THE VISTAS OF WESTCREEK  
AMENDED P.O.A.D.P.  
PLAN No. 167-D

JOB NO. 4492.40 DATE: DEC. 13, 2001 (REVISED)

The City Staff Development Review Committee has reviewed Vistas of Westcreek Development Plan M.D.P. (formerly POADP) Preliminary Overall Area Development Plan # 167-D. Please find enclosed a signed copy for your files. Your plan was accepted however please note the following:

**AMENDED P.O.A.D.P.  
PLAN No. 167-D**

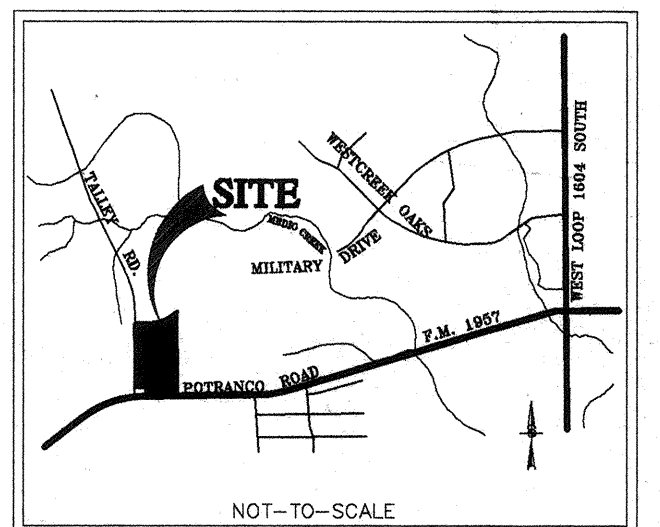
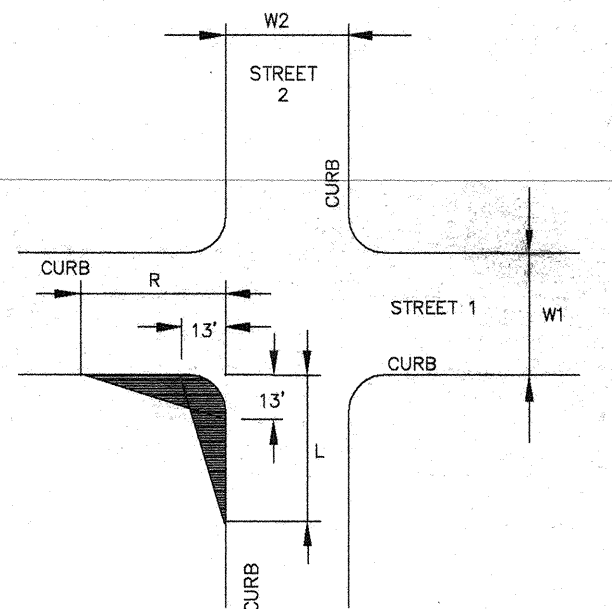
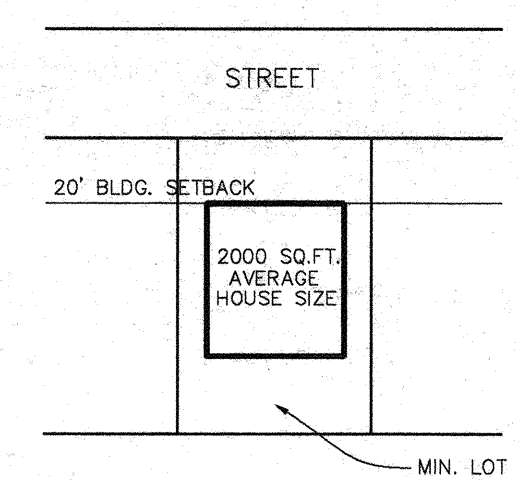
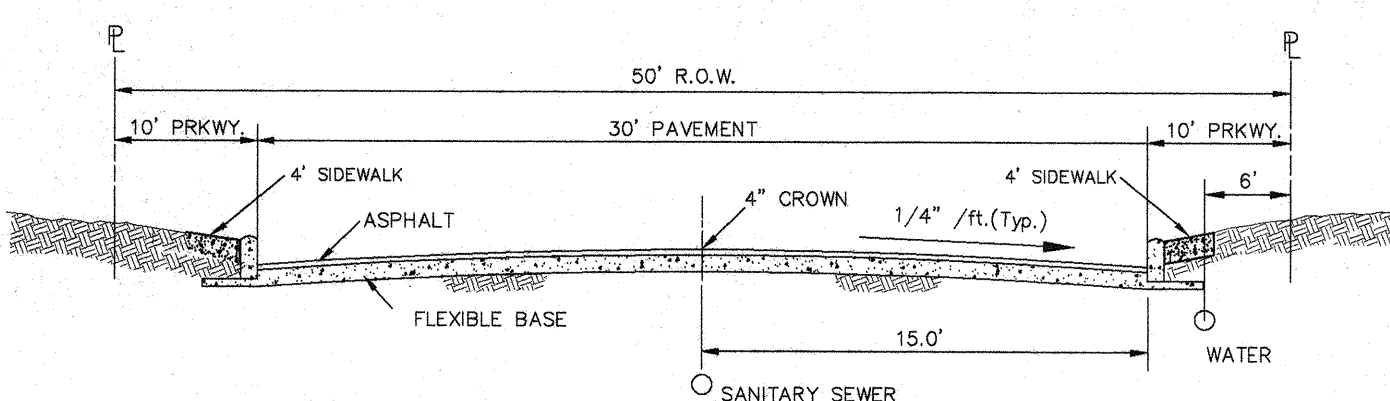
\* ADD NOTE THAT PROPERTY LIES OUTSIDE  
THE CITY LIMITS.

Provide 1' Non-access easements at Potranes, Talley Rd, and Military  
Dr.

Provide a buffer @ cul-de-sac and Military Dr.

COMMENTS John, we have addressed your approved review comments for this POADP. We have added notes to the 2.0 ac. Commercial tract stating it is not a part of the POADP & the POADP is outside the city limits.

COMMENTS Kevin, we have addressed your concerns for this POADP. We have included a 1' non-access easement along Prop Military Dr., Talley Rd & Potranco Rd. and pulled the cul-de-sacs back 10' for a buffer.  
Please call me if you have any questions
